Martis Valley Trail

Final Environmental Impact Report

(SCH #2010122057)

October 17, 2012

EXHIBIT 1
PROPERTY OWNERS
MARTIS VALLEY REGIONAL TRAIL
PLACER COUNTY
985.14B SEPT. 2012

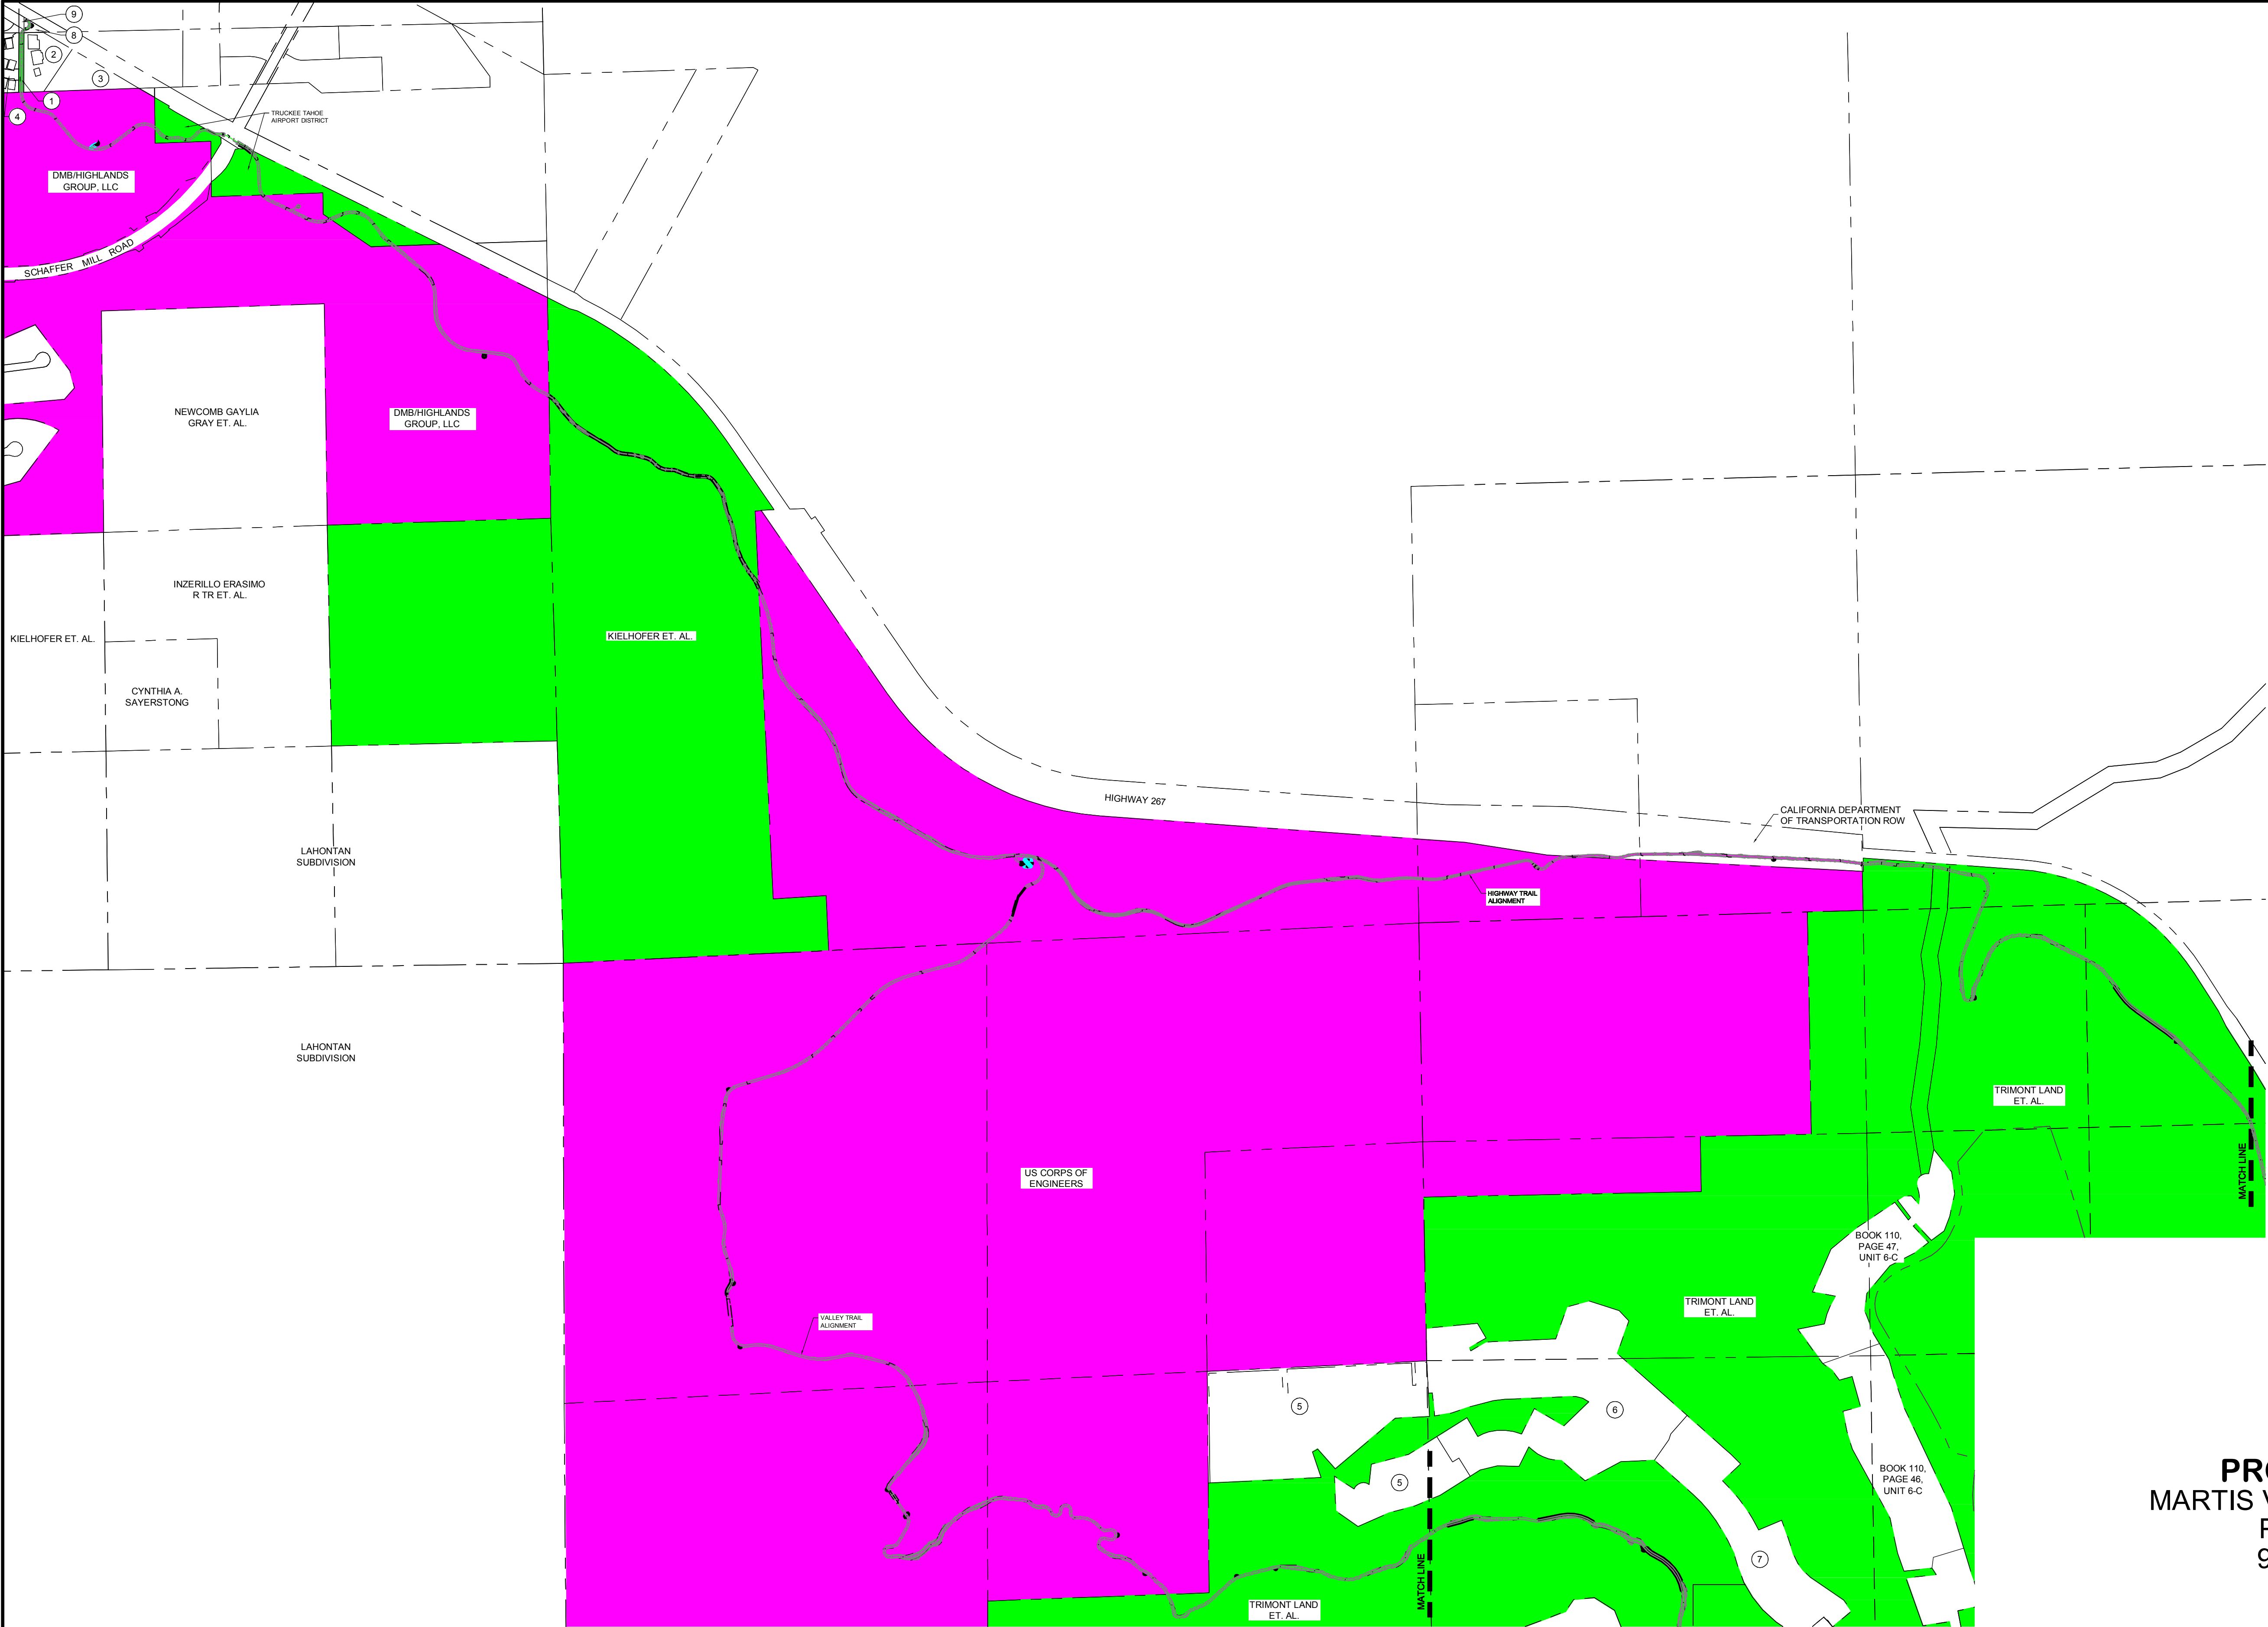
Additionally, Figures 3.1 and 3.2 should be preceded by a map showing property ownership. Under the Cultural Resources Chapter, the prehistory section of the Cultural Setting is barely referenced while the ethnographic and historic contexts are quite expansive. There are numerous prehistoric sites in the Martis Valley with early and middle Holocene components based on recent USACE archeological surveys conducted as part of the DSMP project. Table 5.1: CA-PLA-491/H, this site is also the location of the historic period Cavitt Ranch. This should be in added to the statement about the basalt tool workshop. B-10 B-11 B-12
